This addendum varies the Contract Documents, **THE GATHERING PLACE PHASE 2, VANCOUVER ISLAND UNIVERSITY** and amends the original Drawings and Specifications. The following revisions supersede the information contained in the original drawings and specifications issued to the extent referenced and shall become a part thereof. No adjustment to the Contract Price will be considered or allowed due to the Contractor, or to any subcontractor or Supplier not being familiar with this Addendum.

PROJECT:
THE GATHERING PLACE
VANCOUVER ISLAND UNIVERSITY
NANAIMO, BC

DWG. TITLE:
CEDAR SCREEN
TRANSITION
SLOTS

DRAWING NO:
104
REVISION NO. **0**

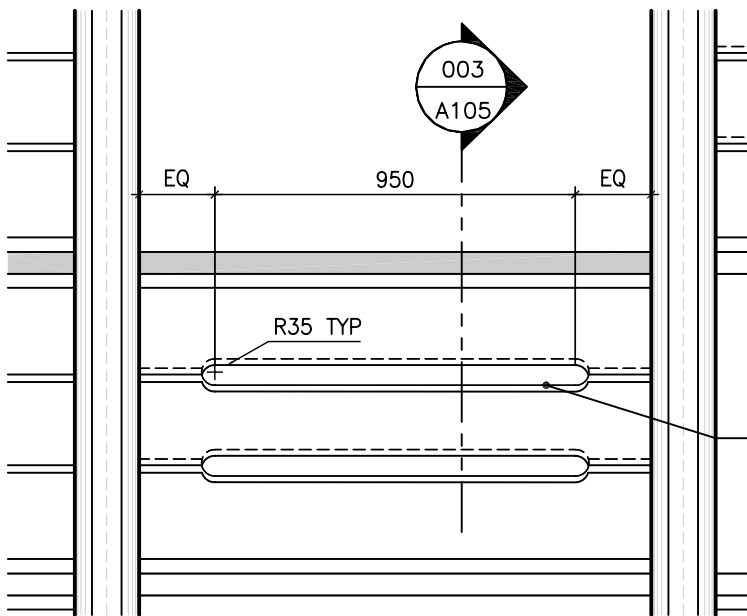
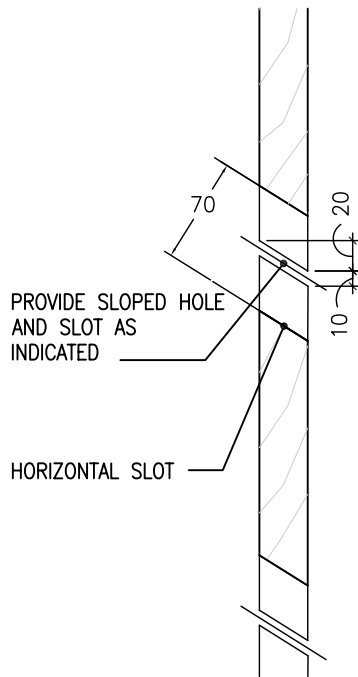
1.1 SLIDING SCREEN

REVISE SLIDING SCREEN AS PER ATTACHED SKA 104 REV.0

PROVIDE SLOTTED SCREEN DETAIL C/W ANGLED HOLE AND SLOT AS DETAILED IN 2/SKA 105 FOR PHASE 1 INCLUDING AND BETWEEN GRIDLINES 3 TO 9+ AND FOR PHASE 2 BETWEEN 15 AND 16+ AS INDICATED IN 1/SKA 105.
